ADDENDUM ORDER #2

NAME OF PROJECT: Town of Crested Butte Wastewater Treatment Facility Improvements

ENGINEER: Schmueser Gordon Meyer Inc.

SHEET: **00G007**

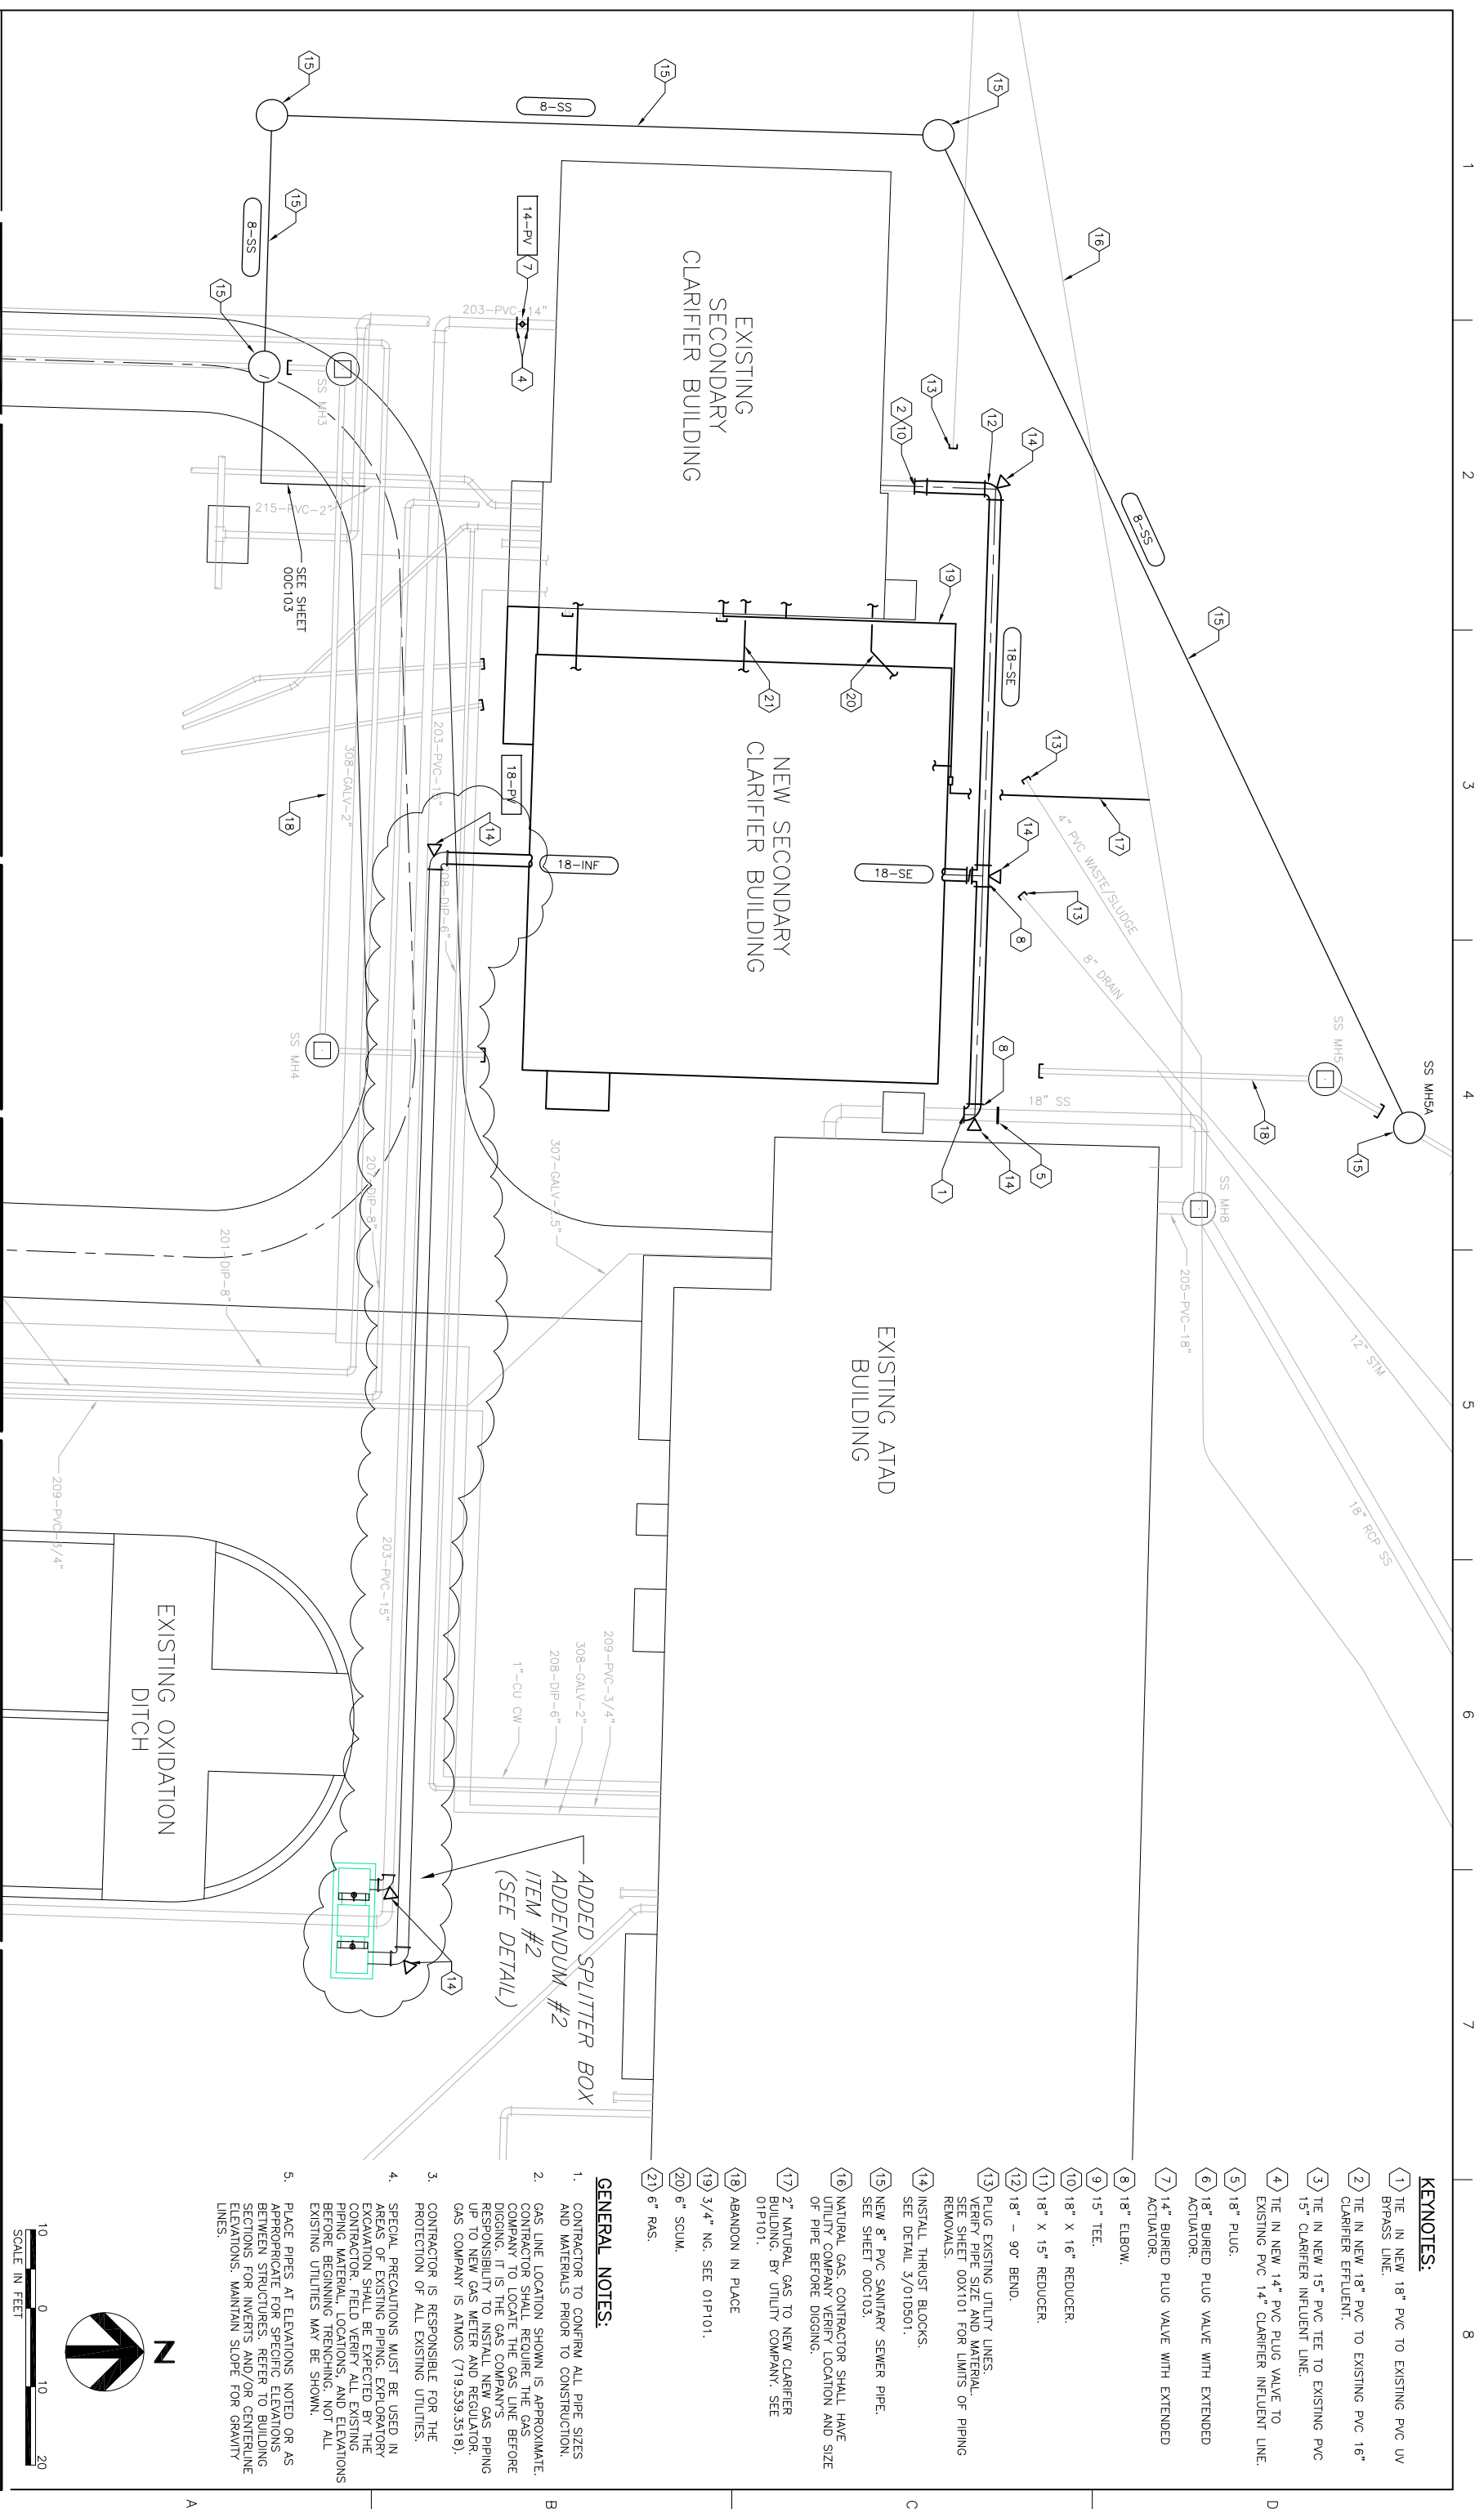
- Additional clarification on the connection piping to RAS pump #2 (shown on revised sheet 00G007): Install approximately 15' of additional 6" pipe, one additional tee fitting, one additional cross fitting and one additional valve all per previously specified materials and types.

ADDENDUM #2 ITEM #1

FILENAME: 00C102.dwg
SCALE: 1"=10'
SHEET: 00C102

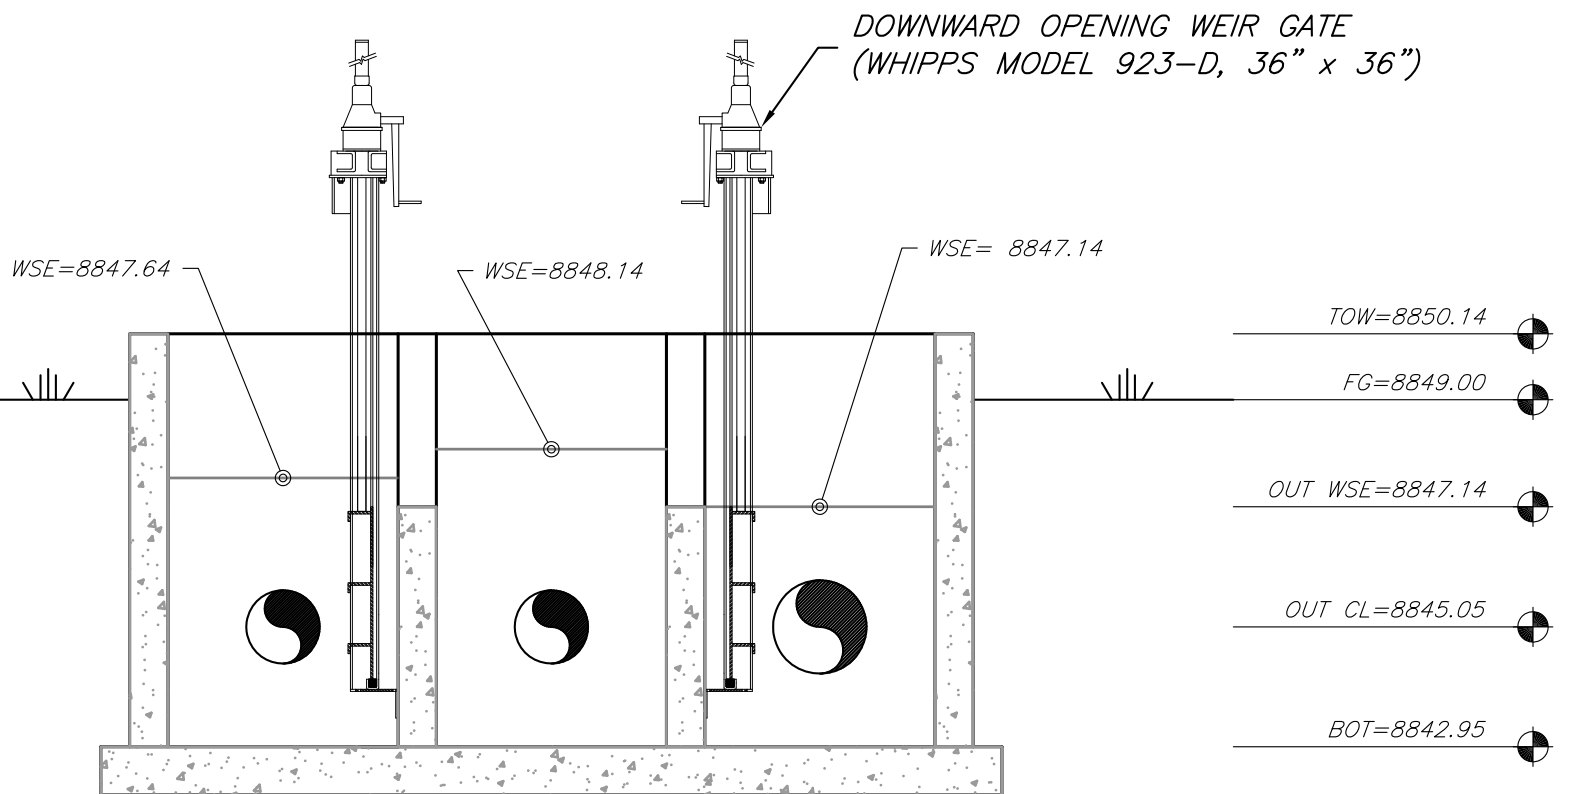
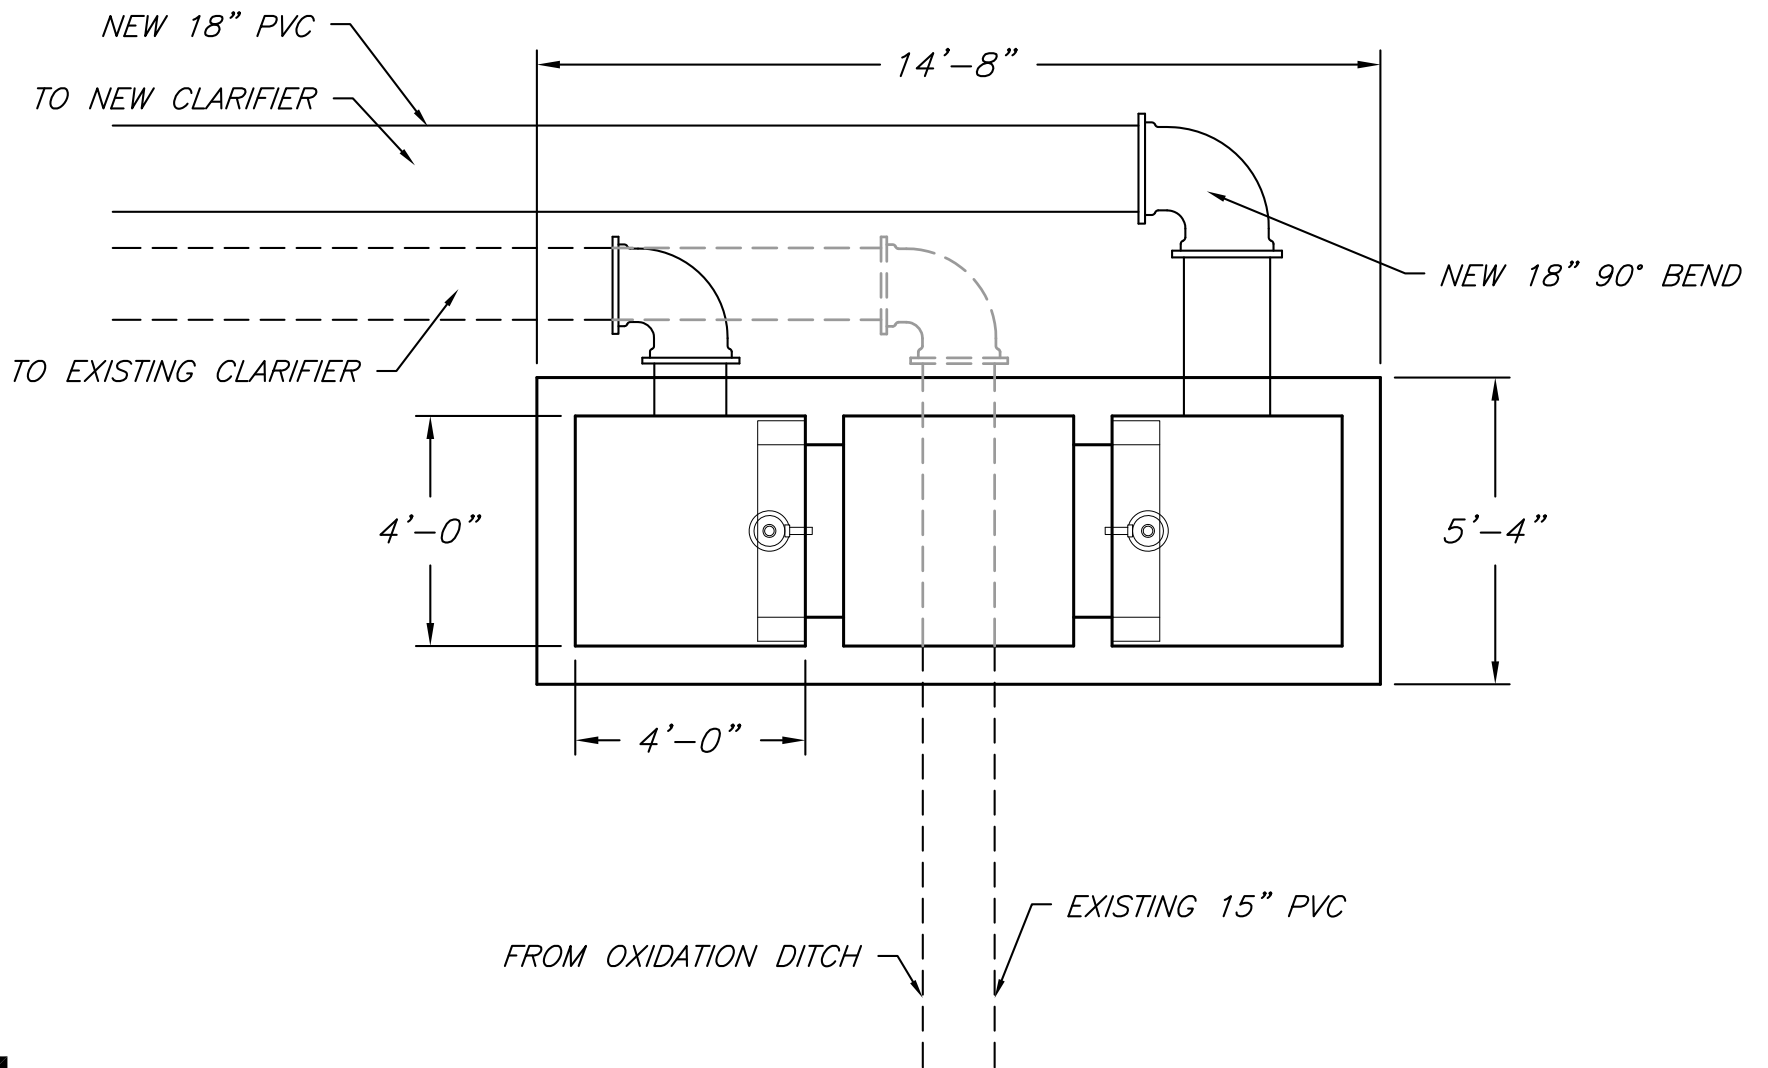
- In place of the new 15" tee, two new plug valves (14" and 18") and 18" X 15" reducer shown on the original drawing sheet 00C102 use a splitter box and additional 18" PVC pipe as shown on revised sheet 00C102 and attached detail drawing.

- Construct the Splitter Box as shown. The intent is for the flow out of the oxidation ditch to enter the center vault of the splitter box. Flow to either, or both, clarifiers will be controlled via weir gates as shown. The existing piping to the existing clarifier shall be modified as shown at the splitter box. Approximately 140' of new 18" PVC pipe to the new clarifier and two elbows will be installed from the splitter box directly adjacent to the existing 15" line and at the same depth. Existing piping from the oxidation ditch shall be terminated in the center splitter box vault. The Splitter Box shall be covered with a steel grate meeting HS-20 load rating.

- Two Whipps Model 923-D weir gates or equal shall be used to split the flow.
- One new 15" PVC 90° bend (and thrust block) and less than 6' of piping shall be used to reconnect to the existing clarifier influent line.

- Two new 18" PVC 90° (and thrust blocks) and approximately 140' of new 18" PVC piping shall be installed directly adjacent to and at same depth as the existing 15" line.

ADDENDUM #2
ITEM #2
